Access Assessment Report

St Aloysius College, Rozelle

Project:	St Aloysius College, Rozelle
Reference No:	113752-Access-r1
Date:	25 October 2021
Client:	PMDL Architecture & Design Pty Ltd
Client Contact:	Andrew Pender
Email:	apender@pmdl.com.au
BCA Logic Project:	Ben Long
Direct:	8484 4009
Email:	blong@bcalogic.com.au

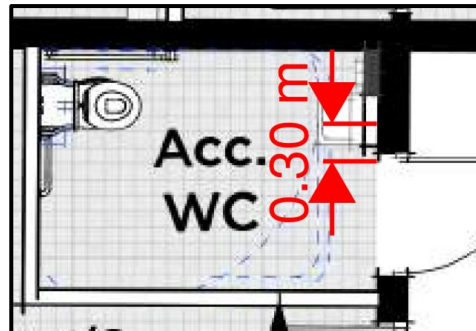
Non-fire-isolated stairways must comply with Clause 11 of AS 1428.1-2009. It is noted that the existing stairways are not provided with handrails that would comply with this Clause. However, it is noted that new handrails are proposed as being provided and these must comply with AS1428.1-2009 and maintain the required extensions and terminations.

However, it is noted that the base of the western stairway there is a portion of the brick wall/column? which is offset and will reduce the clearance maintained between the handrails or the handrails and the wall. Pending the impact on the existing wall it may be possible to seek a Performance Solution to allow for a reduced clear width between the handrails for a small portion or to allow for a single handrail to not maintain the extension as required.

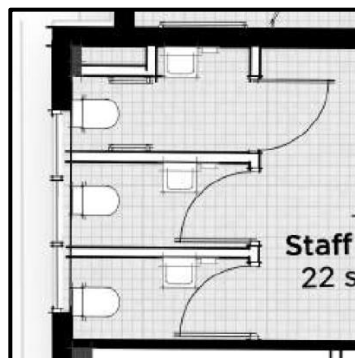
When reviewing the proposed accessible sanitary facility, the latchside clearance within the room would not be maintained due to the location of the handwash basin?.

Additionally, it is noted that only a single ambulant sanitary compartment is proposed for the staff facilities. As part of the BCA Report, it is required that two of these WCS are allocated to Female and one WCs is allocated to male. Therefore, it would be required that there are two ambulant facilities provided in accordance with AS1428.1-2009.

As part of the detailed design and ongoing documentation it would be required that the plans are to swing the door inside the sanitary compartment but have the basin located 300mm clear of the door swing in accordance with AS1428.1-2009.

As part of the detailed design and ongoing documentation it would be required that the plans are updated to include an ambulant facility for male and for female use.
